**RE: PROPOSED CONSTRUCTION OF PASSENGER TERMINAL  
BUILDING AT LANET AIRSTRIP**

**TENDER NO: KAA/OT/ES/LANET/0008/2021-2022**

**ADDENDUM NO. 3**

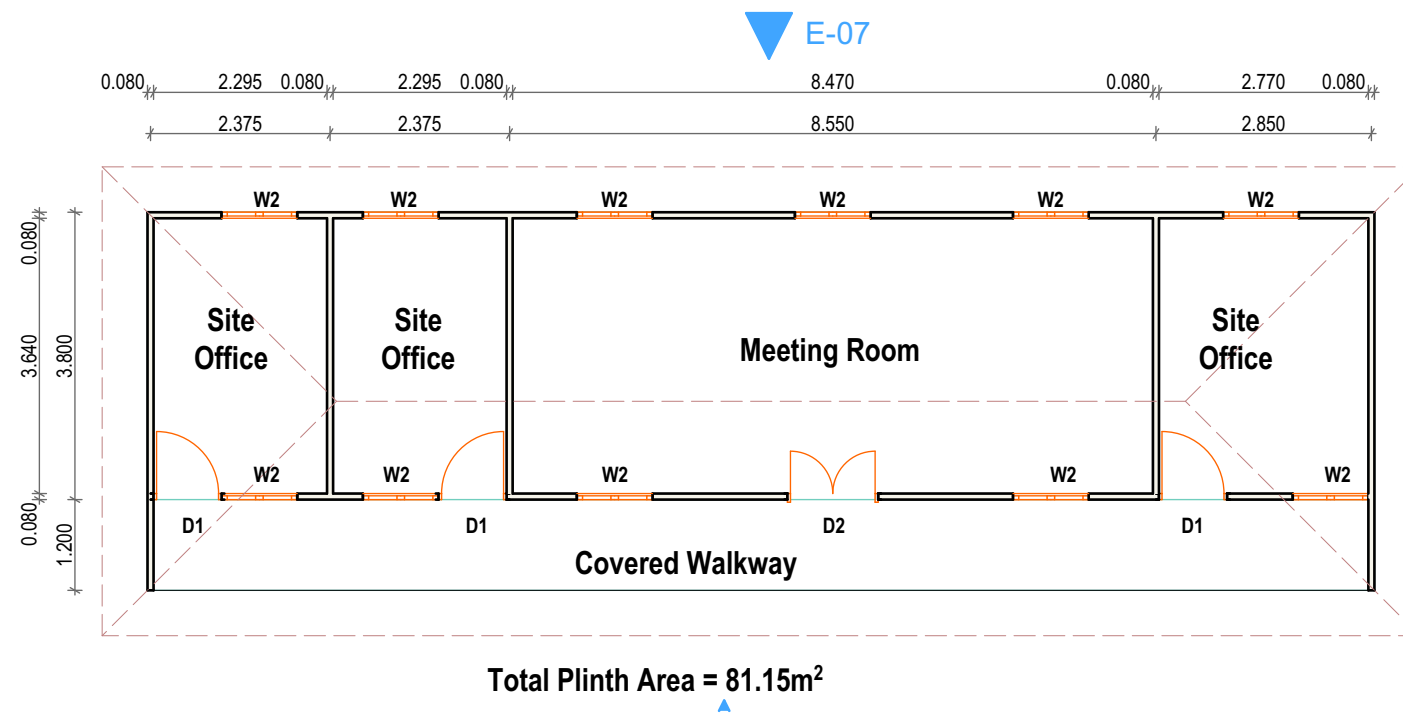
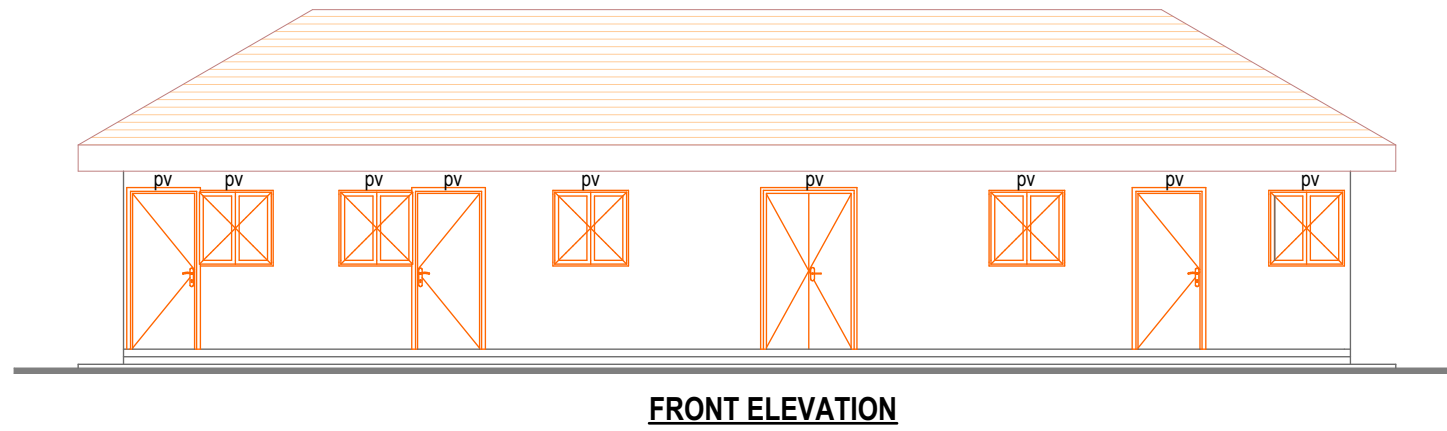
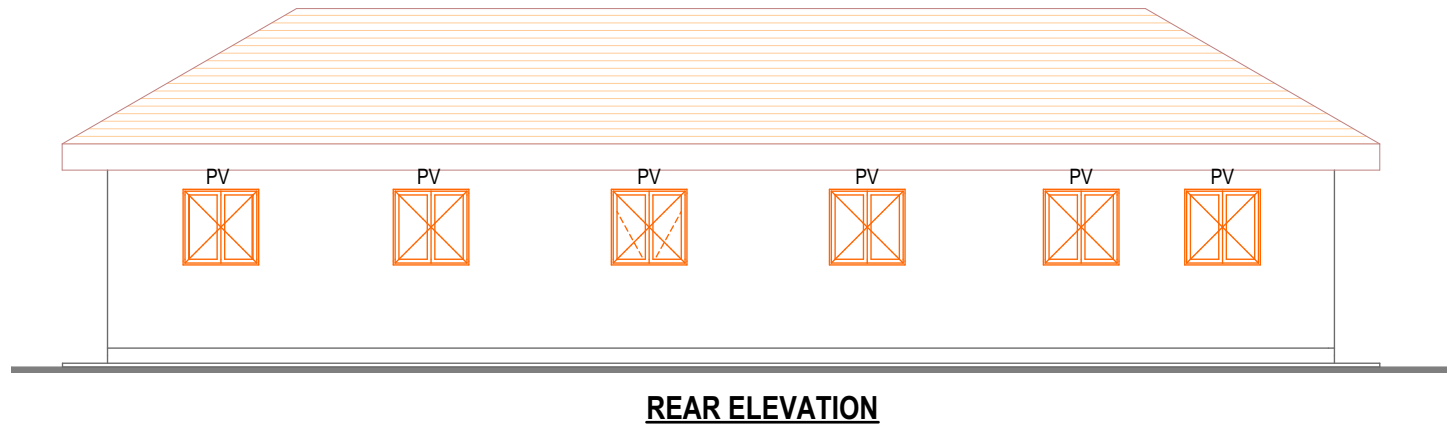
Site office drawings (2 No. buildings) are issued/sent out with this addendum; amend as follows:

TITLE: PROPOSED CONSTRUCTION OF PASSENGER TERMINAL BUILDING AT LANET AIRSTRIP					BILL No. 1
ITEM No.	DESCRIPTION	UNIT	QUANTITY	RATE	AMOUNT KShs cts
27	<u>SITE OFFICES (AS PER DRAWING)</u>				
A	<p>The Contractor must allow for erecting and maintaining site office for employer's project management use, to revert to the employer as per drawing (plinth area 81.15m2). The Contractor shall allow for providing, erecting and maintaining where directed a lock up hut containing a pedestal type water closet and wash basin for the sole use of the Project Manager and other consultants, including making temporary connections to drains and water supplies and paying all charges for connections, conservancy and water consumed.</p> <p>The Contractor shall also allow for providing the services of a sweeper, for keeping both office and closet in a clean and sanitary condition from the commencement to completion of the works to revert to employer. The office and closet shall be completed before the Contractor will be permitted to commence the works.</p> <p>The contractor shall also provide on the site in such positions as may be directed, adequate site offices (plinth area = 199.143SM) for the use of his own site staff to be handed over to the employer, in good condition at completion. Both site offices shall have sufficient furniture as per furniture list to permit the Project Manager to hold site meetings in it. The offices to be made of sandwich panels composed of two steel layers injected in between with polyurethane foam. The steel sheet layers are hot dipped galvanized and polyester coated, all sandwich sheets panels are painted with reflective, anti-dust and durable electrostatic paint from both sides.</p>	ITEM
